UNITED STATES
NUCLEAR REGULATORY COMMISSION

SUBJECT: KEWAUNEE NUCLEAR POWER PLANT - REQUEST FOR EXEMPTION FROM THE REQUIREMENTS OF 10 CFR PART 50, APPENDICES G AND H, AND 10 CFR 50.61 (TAC NO. MA8585)

NRC STAFF METHOD EVALUATION

Figure 1 - Current KNPP RPV Cooldown P-T Limit Curves Through 28 EFPY

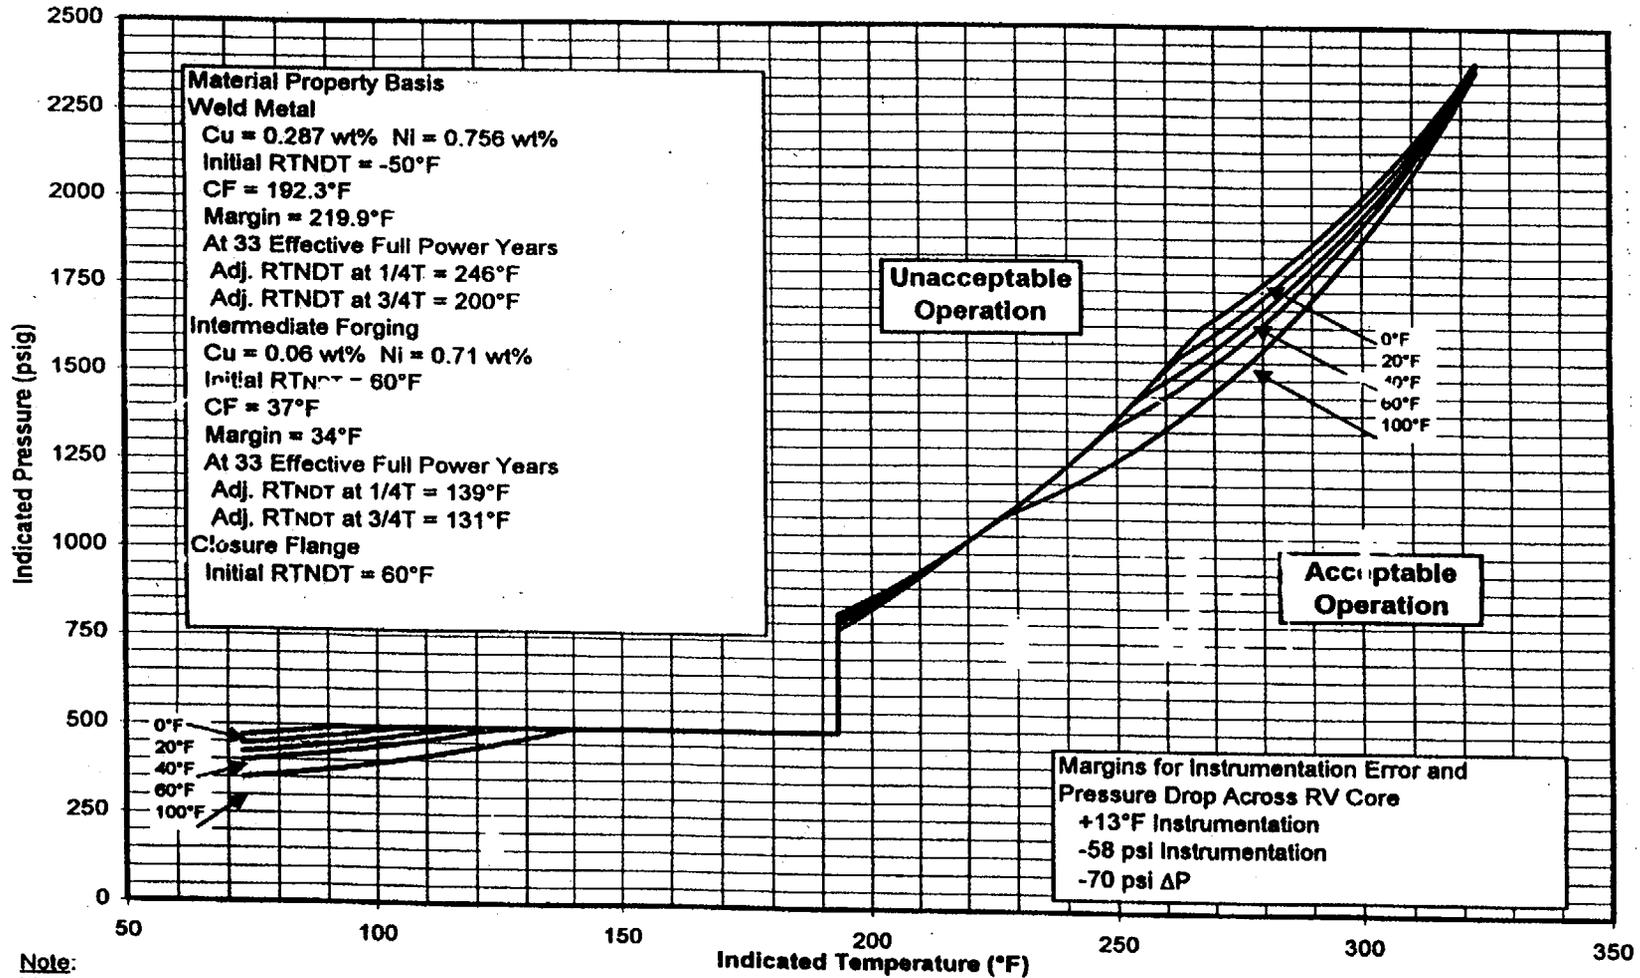
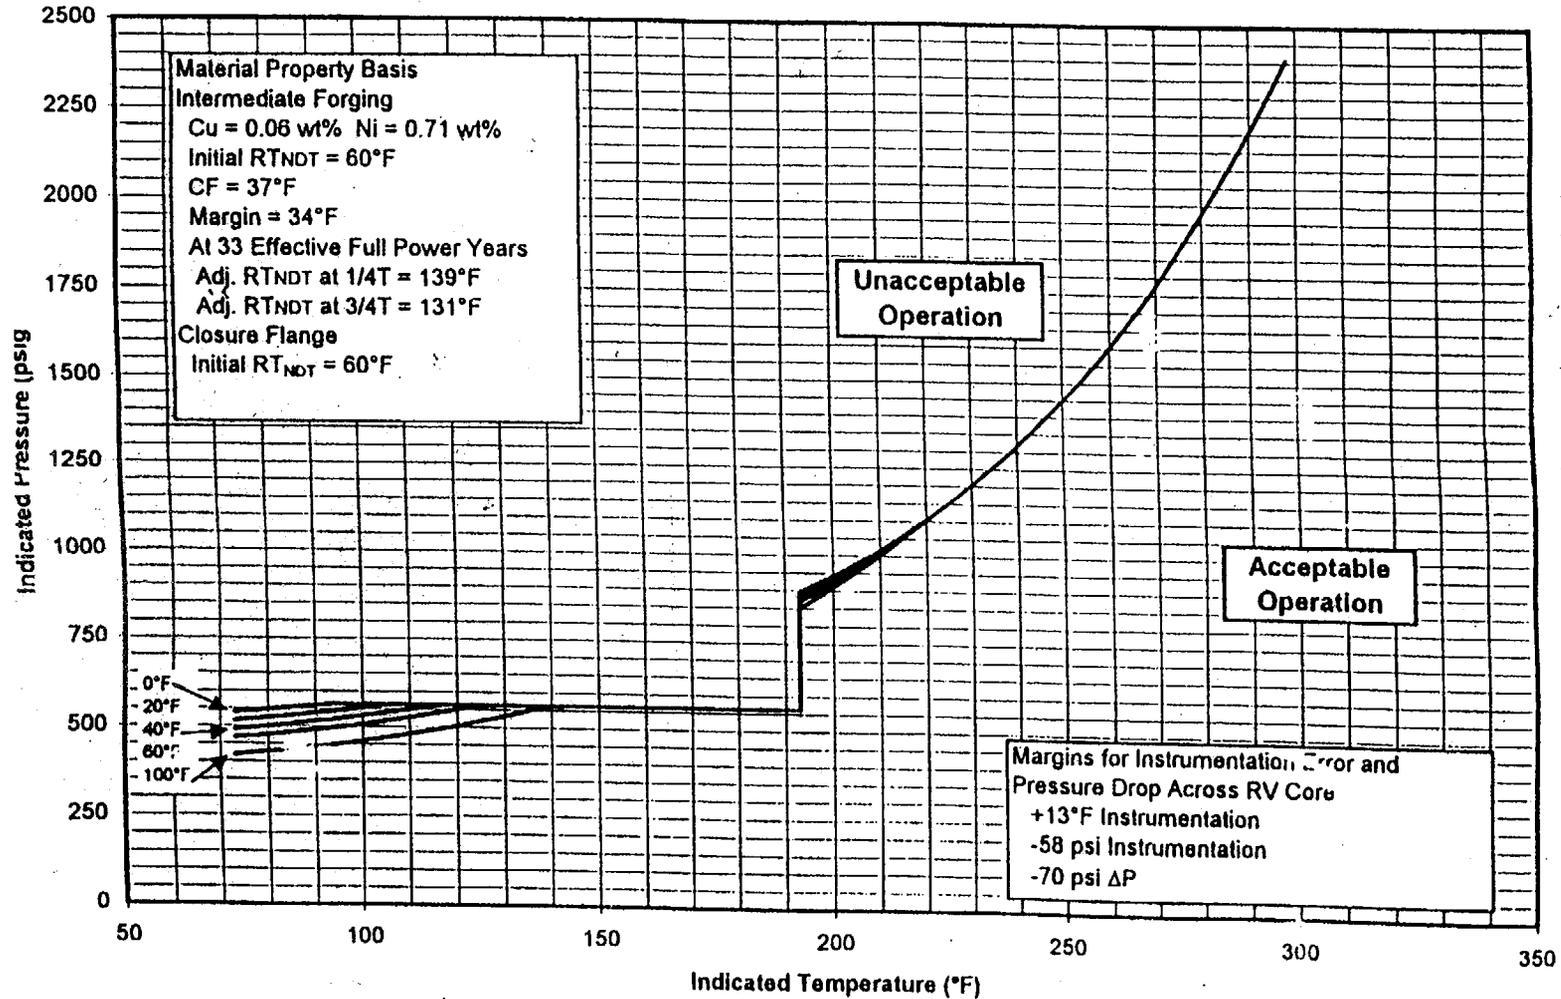
However, the NRC staff did note that in the NRC staff SE which granted approval for the current KNPP P-T limits, a restriction on their validity to 28 EFPY of operation was imposed because the NRC staff calculated the cooldown curves in Figure 1 to be 5 to 7 °F non-conservative at 33 EFPY.^[31] This was based on the NRC staff's conclusion that the EOL 1/4T and 3/4T reference temperatures for the KNPP RPV circumferential weld (under the Charpy V-notch and drop weight-based methodology) would be 256 °F and 210 °F, respectively. Reestablishing the EOL 1/4T and 3/4T reference temperatures as 247 °F and 196 °F, respectively, using the NRC staff's Master Curve-based approach, "corrects" for this 5 to 7 °F non-conservatism in the current KNPP cooldown P-T limit curves and would justify, if requested by the licensee, their use through 33 EFPY of operation. The NRC staff's prior conclusion, that the other current KNPP P-T limit curves (e.g., the heatup limit curves, which were based on the material properties of the most limiting KNPP beltline forging and the limiting RPV closure flange material) would be acceptable through 33 EFPY, remains valid.

Figure 3 - Plot of Available Data Sets Containing Both PCVN and 1T-CT or Larger Data to Estimate the Bias in PCVN T_0 Results as a (Potential) Function of the Constraint Parameter, M_0 for the PCVN data set.

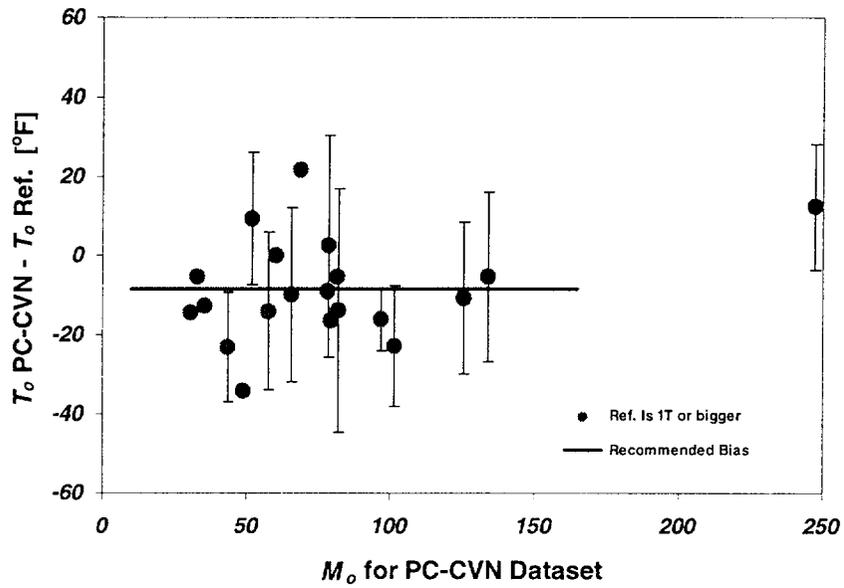
From Figure 3, the NRC staff concluded that although a statistically significant bias of 8.5 °F was evident in the data, no defined trend with M_0 was able to be resolved. The NRC staff also observed other data points for which " T_0 Ref." values could be calculated from specimens as small as 0.5T-CTs. With the inclusion of this additional data, a trend of increasing PCVN bias with decreasing M_0 may have been resolvable, but the complication of including data wherein the size (and thus the expected constraint) of the specimens used to define " T_0 Ref." was nearly the same size as the PCVN specimens would have made any such conclusions highly speculative. It can, however, be noted that with regard to addressing bias related to the licensee application, either interpretation would have yielded the same net effect in the NRC staff's overall methodology.

The NRC staff acknowledges that the lack of a definable trend in Figure 3 calls into question whether the observed bias from PCVN test results can be simply addressed as a matter of specimen constraint. Other theories have been postulated, including consideration of specimen geometry and T-stress, to explain the observed differences in PCVN and CT specimen results. The NRC staff recognizes that additional research in this area may help to better define this issue and modify the conclusions of this SE. However, the NRC staff concludes, at this time, that the assumption of a 8.5 °F bias in PCVN-based T_0 values relative to values obtained with larger size CT specimens, to be applied to each unirradiated and irradiated PCVN data set in the licensee submittal, is adequate to address this potential source of non-conservatism in the NRC staff's methodology as developed in Appendix A to this SE.

The methodology developed by the NRC staff, however, includes sufficient flexibility to incorporate specific bias values for each of the four PCVN data sets relevant to this evaluation of the KNPP RPV circumferential weld should additional information demonstrate that different bias values are appropriate. To provide this flexibility, each of these four data sets must be addressed separately since the effect of bias on the evaluation of the shift in T_0 must be assessed given the NRC staff's methodology discussed in Section 1.3.2 above. As such, the effect of "accounting for bias in PCVN data" in the NRC staff's methodology cannot be easily discussed as a stand alone item, but must instead be presented as it is integrated into achieving results from the overall NRC staff methodology. This integration of bias into the NRC staff's methodology is addressed in Appendix A and discussed further in Section 1.3.5 below.
